Response to U.S. EPR Design Certification Application RAI No. 422, Supplement 26

Response to
Request for Additional Information No. 422, Supplement 26

U.S. EPR Standard Design Certification
AREVA NP Inc.
Docket No. 52-020
SRP Section: 03.09.02 - Dynamic Testing and Analysis of Systems Structures and
Components
Application Section: 3.9.2

Figure 03.09.02-88-1—U.S. EPR SG Upper Internals

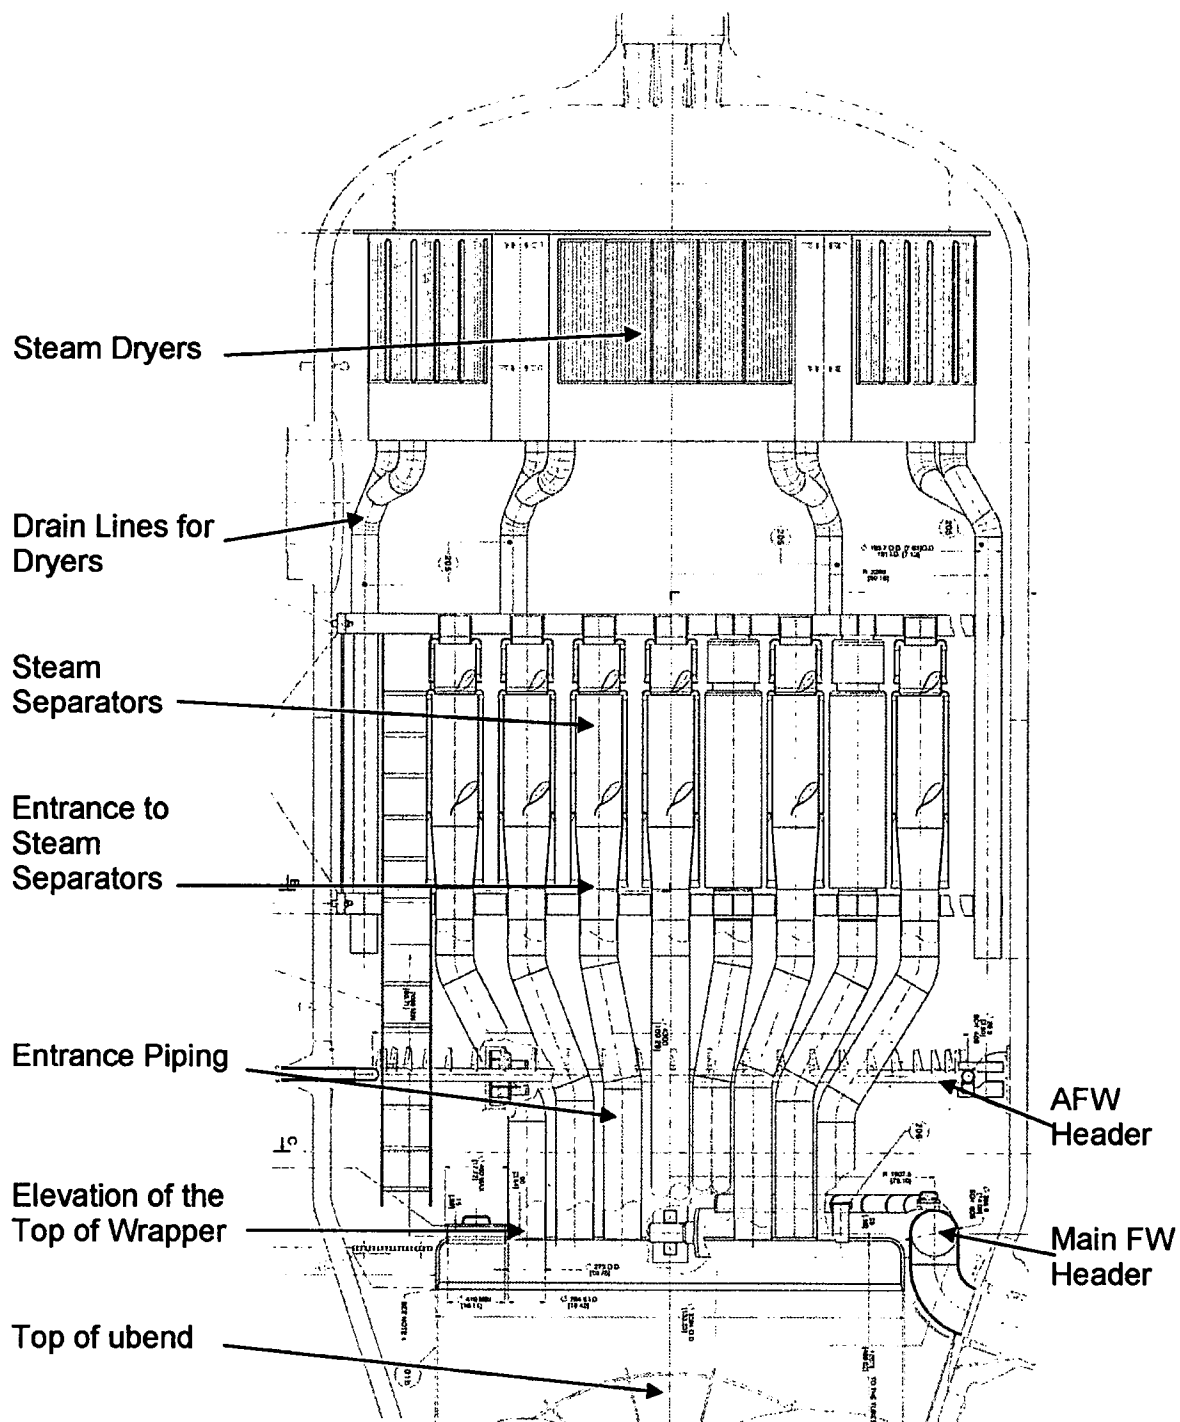
The applicant responded to RAI 03.09.02-59 in the response to RAI 245 by referencing the CVAP. The staff noted that the analysis of other components within the recirculating steam generator (RSG) is briefly discussed in CVAP Section B.5 together with a statement that the analyses show that the components will not experience excessive flow induced vibration. The staff noted that neither the analyses nor the results are provided and therefore the staff could not determine if RSG components are vulnerable to flow induced vibration. Each issue associated with FIV of RSG components that requires resolution of RAI 03.09.02-59 is described below.

The staff noted that the U.S. EPR has a significantly higher mass flow of steam through the RSG (17.8 percent higher than Doel and Tihange units, and 8.5 percent higher than the CZB and CV units). The applicant is request to discuss the significance of the higher flow rate through the steam dryers with respect to nominal velocity, surface area and the similarity of the four comparison plants.

The recirculation flow from the U.S. EPR primary steam separators and dryers is approximately [] percent of the secondary side flow rate through the tube bundle, as reported in Technical Report ANP-10306P, Comprehensive Vibration Assessment Program for U.S. EPR Reactor Internals, Table B-1. Referring to Figure 03.09.02-88-1, the recirculation flow is drained from the steam dryers in the upper internals through drain piping located in the periphery of the steam drum to an elevation just below the entrance to the steam separators. The majority of the recirculation flow from the steam separators is discharged from the first stage, which is located at the entrance to the separators as shown in Figure 03.09.02-88-1.

Given the large flow area created by the boundary of the steam generator (SG) upper shell and the small magnitude of the single-phase recirculation flow, the SG upper internal components identified in Technical Report ANP-10306P, Section B.5—e.g., the main feedwater distribution system, the emergency feedwater header rings— cannot experience significant flow excitation due to random turbulence from the recirculation flow. The location of the drain piping in the periphery of the steam drum, away from the steam separator exhaust, eliminates the possibility for this flow to create flow excitation of the drain piping due to random turbulence or vortex-shedding.

Although the secondary side mass flow rate for the US EPR steam generator (SG) is [] percent higher than the SG identified in Technical Report ANP-10306P, Table B-1, the U.S. EPR SG upper internal components are not susceptible to significant flow excitation for the reasons identified.
